V2500 Propulsion System — Nacelle

Subject: Transmittal of Revision 3 to Service Bulletin Number V2500-NAC-26-0011

NACELLE - EXHAUST - SUPPORT BRACKETS, OVERHEAT DETECTOR, THRUST REVERSER
MODIFICATION OF

V2500-NAC-26-0011

Overheat Detector Support Bracket Modification
Figure 1 (Sheet 1)

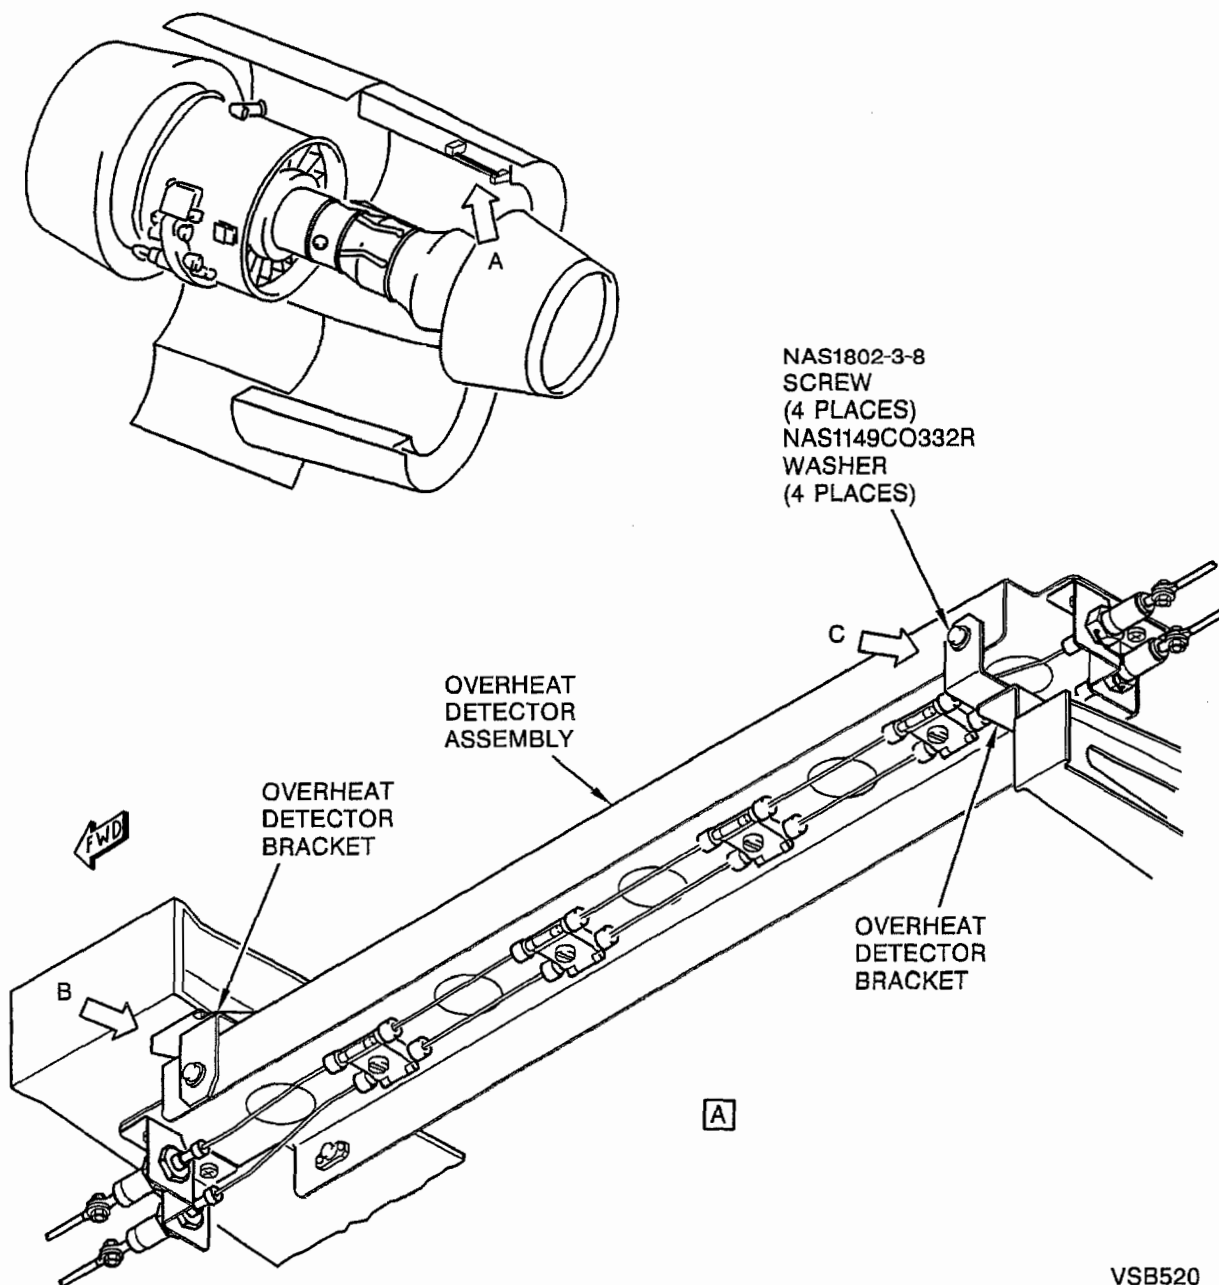
- (1) Remove the four NAS1802-3-8 screws, NAS1149C0332R washers and the overheat detector assembly from the support brackets. Refer to Figure 1 (Sheet 1).

- (1) Remove the rivets and the 290-5265-501 bracket assembly from the latch housing. Refer to Figure 1 (Sheet 1).
- (2) Remove the rivets and separate the 290-5265-3 bracket from the 290-5265-5 bracket. Discard the 290-5265-5 bracket. Keep the 290-5265-3 bracket. Refer to Figure 1, Detail B.

- R (1) Install the overheat detector assembly on the support brackets with the NAS1149C0332R washers and NAS1802-3-8 screws. Torque the screws to 20-25 inlbs (2.26-2.82 N.m). Refer to Figure 1 (Sheet 1).

Overheat Detector Support Bracket Modification
Figure 1 (Sheet 2)

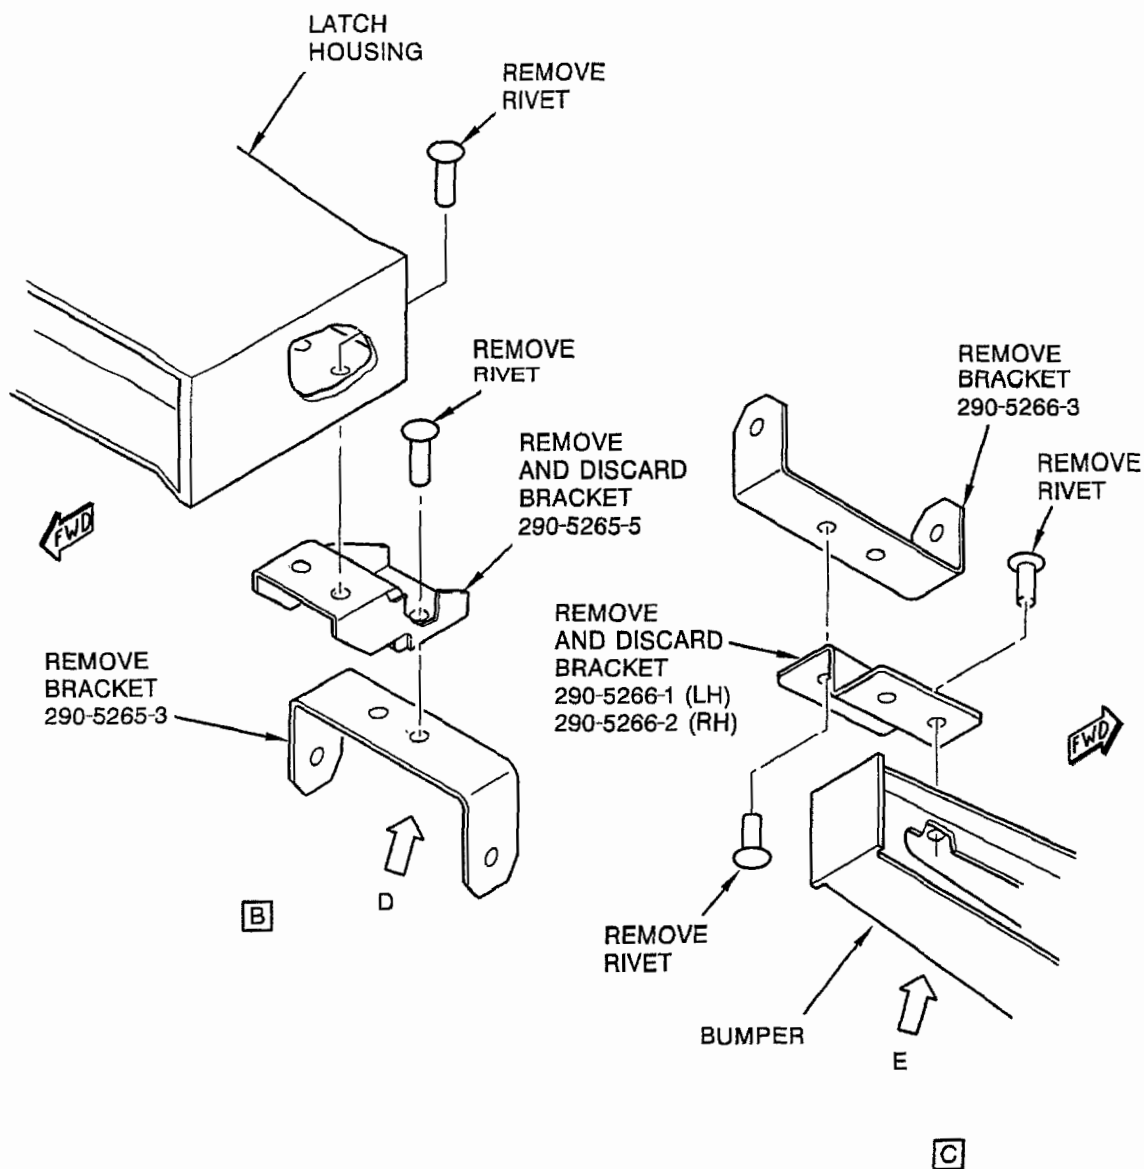
- (3) Make the holes in the 290-5265-3 bracket and the latch housing 0.192-0.203 inch (4.88-5.16mm) for the NAS7802U2 bolts.
- (4) Attach the modified 290-5265-3 bracket to the 290-5265-7 (290-5265-8) bracket with the NAS7802U2 bolts, NAS1149CN816R washers, and MS21043-08 nuts. Torque the nuts to 50-70 inlbs (7-9 Nm). Refer to Figure 1, Detail D.

- (6) Install the 290-5265-503 (290-5265-504) bracket assembly on the latch housing with the NAS7802U2 bolts, NAS1149CN816R washers, and MS21043-08 nuts. Torque the nuts to 50-70 inlbs (7-9 Nm). Refer to Figure 1, Detail D.

- R (1) Remove the rivets and the 290-5266-501 (290-5266-502) bracket assembly from the bumper. Refer to Figure 1, Detail C.
- (2) Fill the holes in the bumper with NAS1200M4-4 rivets. Refer to Figure 1, Detail F.

- R (3) Remove the rivets and separate the 290-5266-3 bracket from the 290-5266-1 (290-5266-2) bracket. Discard the 290-5266-1 (290-5266-2) bracket. Keep the 290-5266-3 bracket. Refer to Figure 1, Detail C.

Overheat Detector Support Bracket Modification
Figure 1 (Sheet 3)

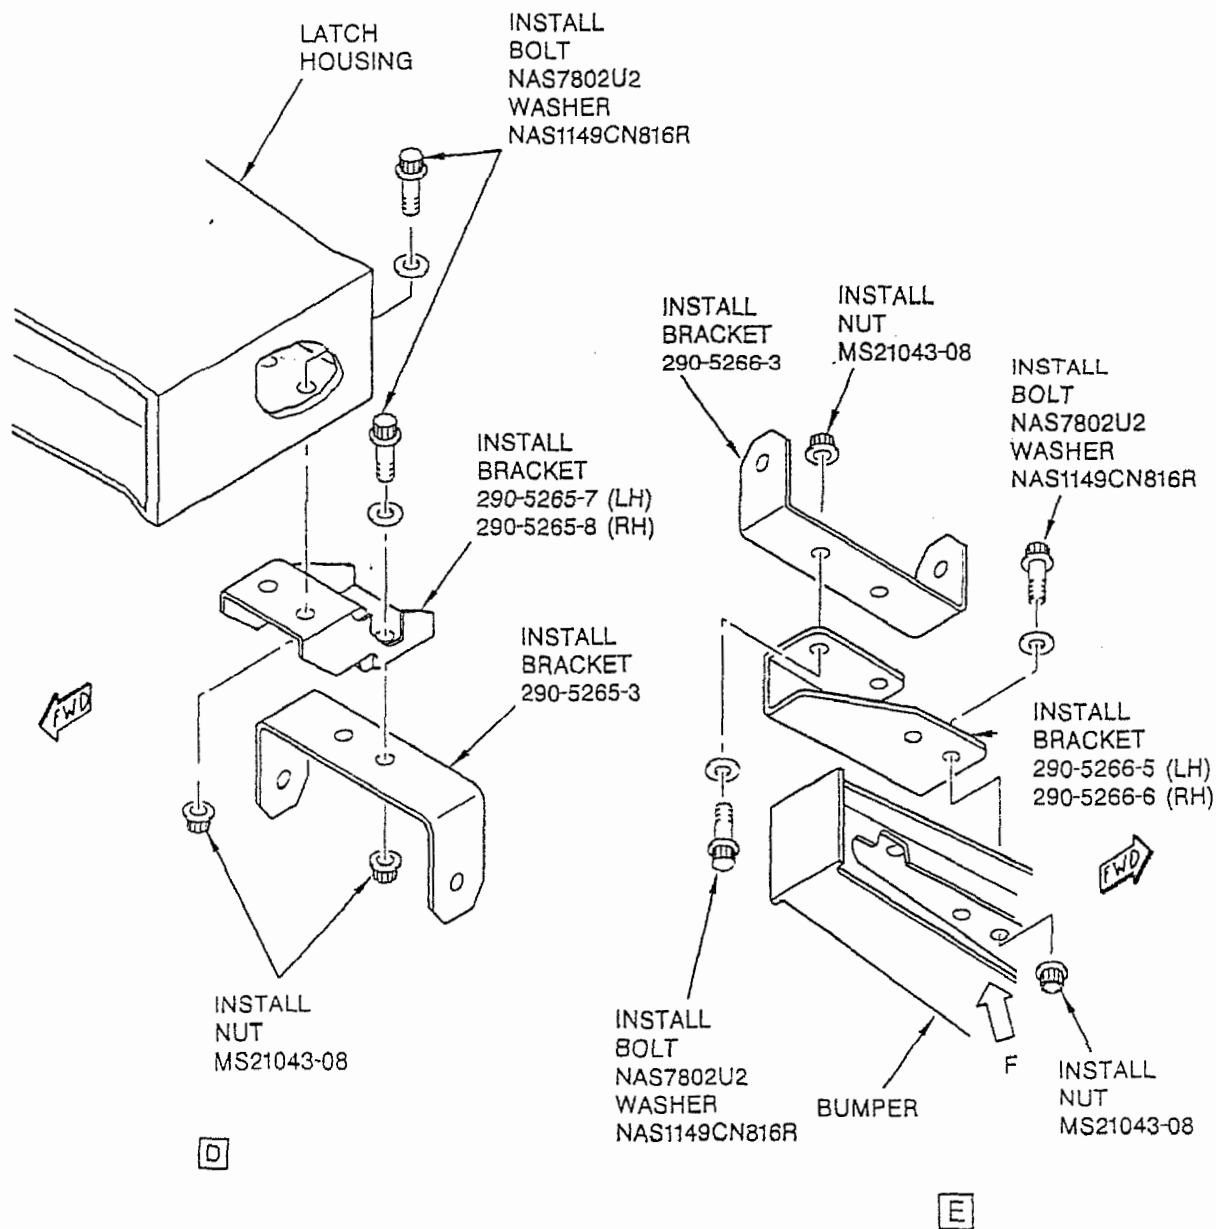
- (4) Make the holes in the 290-5266-3 bracket 0.192-0.203 inch (4.88-5.16mm) for the NAS7802U2 bolts.
- R (5) Attach the modified 290-5266-3 bracket to the 290-5266-5 (290-5266-6) bracket with the NAS7802U2 bolts, NAS1149CN816R washers, and MS21043-08 nuts. Torque the nuts to 50-70 inlbs (7-9 Nm). Refer to Figure 1, Detail E.

- R (7) Drill two 0.192-0.203 inch (4.88-5.16mm) holes in the bumper as shown in Figure 1, Detail F.
- R (8) Install the 290-5266-503 (290-5266-504) bracket assembly on the bumper with the NAS7802U2 bolts, NAS1149CN816R washers, and MS21043-08 nuts. Torque the nuts to 50-70 inlbs (7-9 Nm). Refer to Figure 1, Detail E.

Overheat Detector Support Bracket Modification
Figure 1 (Sheet 4)

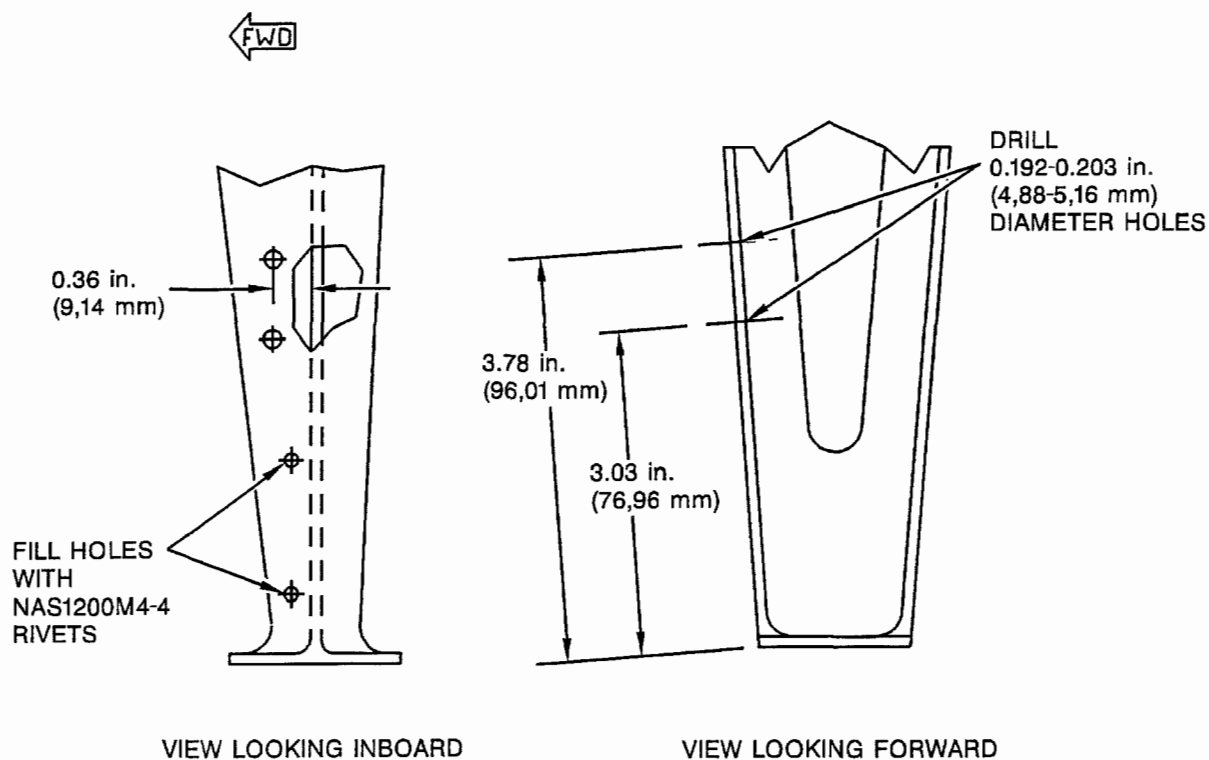
(1) To correct inch-to-millimeter conversion in Figure 1 (sheet 4).
